Docket Number 50-346

Subject: Davis-Besse Nuclear Power Station, Unit Number 1  
Supplemental Information Regarding License Amendment Application to Revise  
Technical Specification (TS) 3/4.5.2, Emergency Core Cooling Systems – ECCS  
Subsystems –  $T_{avg} \geq 280^{\circ}\text{F}$   
(License Amendment Request No. 03-0008; TAC No. MB8953)

**COMPLETION OF RESPONSES TO NRC REQUESTS FOR ADDITIONAL  
INFORMATION**

Figure 1. Full Power, High Decay Heat Post LOCA Representative Pressure-Time Histories

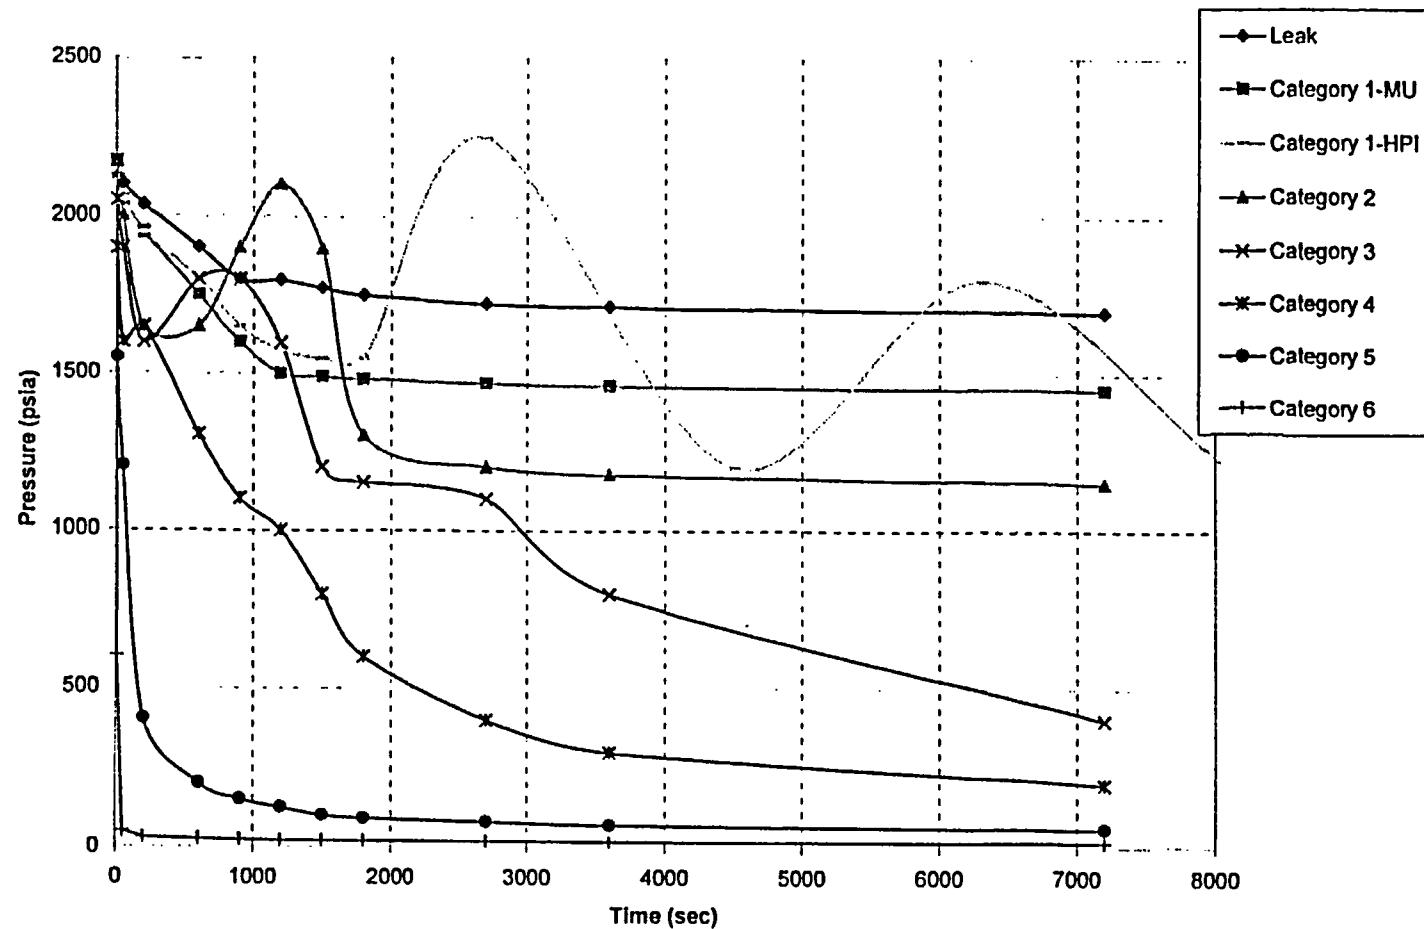
43. Provide docketed copy of the RCS pressure/time histories (full power as well as Mode 3) as supplied by FANP.

With these actions, the RCS remains in forced or natural circulation and the operators can use the steam generators to depressurize the system during the longer term phase of the event. The short term pressure response is shown in Figure 1 for leaks from full power initial conditions with high core decay heat levels.

If the MU pump flow is not included, the HPI pumps would not provide sufficient ECCS injection at the higher RCS pressures to match the break flow. The system inventory loss would cause natural circulation to be interrupted. This interruption in flow would result in initiation of core boiling and RCS repressurization above the HPI shutoff head. When the RCS pressure is above the HPI shutoff head, the RCS liquid inventory decreases due to the break flow. The RCS inventory will cause the RCS levels to decrease. When the primary levels descend into SG tube bundle below the AFW injection location, a high-elevation boiler-condenser mode (BCM) of heat transfer is established in the SG. The SG heat removal would decrease RCS pressure well below the HPI shutoff head. The HPI flow would be reestablished and it would exceed the break flow for the smallest break sizes in this category. The HPI flow would refill the RCS above the AFW injection location and the SG heat transfer would be interrupted. The RCS would repressurize again above the HPI shutoff head and the cycle would be repeated unless natural circulation could be regained. The RCS pressure could cyclically oscillate between the secondary side pressure and 1800 to 1900 psia for the smaller breaks in this category. These oscillations could last for days or weeks with only a slight decrease in the peak pressure as the core decay heat rate decreased. Figure 1 shows this response labeled as Category 1-HPI.

Once natural circulation is lost, it is difficult to refill the RCS and reestablish single-phase natural circulation in at least one loop with flow from only the HPI pumps. If the MU pumps are available or the PORV is opened, the RCS can be refilled. Once refilled, the SG cooldown allows the RCS to be cooled to the conditions at which the LPI system can be initiated. Therefore, credit for flow from the makeup pumps is key in the response for Category 1. The RCS pressure for a Category 1 break with flow included from the MU pumps is shown as Category 1-MU in Figure 1.

These moderate break sizes limit the RCS depressurization rate shown in Figure 1. Generally, it takes 25 to 60 minutes (depending on break size, decay heat power, and steam generator heat removal) for these break sizes to depressurize the RCS to the CFT pressure. During this time period, the core decay heat boils off the HPI flow that reaches the core and some of the RCS liquid inventory that drains into the reactor vessel. The continuous HPI flow delivery to the vessel is most critical for these break sizes, because the RCS liquid inventory available to augment the ECCS is only capable of providing 5 to 10 minutes of core boiloff before the core uncovers.

The AFW fill logic and AFW flow rate are less important on these transients because of the larger break size. Nonetheless, higher AFW flow rates can be beneficial in accelerating the RCS depressurization rate, holding up slightly more liquid in the hot leg and steam generator tubes, and reducing the steam generator reverse heat transfer. Figure 1 shows the characteristic pressure response for the Category 4 break sizes.

Break sizes greater than 0.25 ft<sup>2</sup> (but less than 0.75 ft<sup>2</sup>, the upper range of SBLOCAs) are sufficiently large to depressurize the RCS to approximately that of the containment pressure as shown in Figure 1. These breaks are not large enough to reverse core flow, which would cause the cladding to exceed the critical heat flux upon break initiation. The core is shut down via control rods and cooled during the blowdown transient, which maintains a two-phase mixture that keeps the fuel pin cladding within a few degrees of saturation so long as the mixture level remains above the top of the core. During the rapid depressurization to the CFT pressure, some of these break sizes may cause some core uncovering and cladding heatup. For breaks with the RC pumps running for the first two minutes after LSCM, this situation is exacerbated, because the pumps push additional ECCS and RCS liquid to the break site. The duration of the uncovering is short since CFT flow quickly refills the core and quenches the clad temperature. Depressurization to the LPI initiation pressure will occur within the first two to ten minutes post LOCA, therefore HPI inflow during these first several minutes is of little consequence for core cooling prior to the time of core refill so long as the LPI liquid reaches the vessel. After the CFTs are empty and the core is refilled, however, LPI and HPI flow provide both diversity of makeup injection sites and more than sufficient
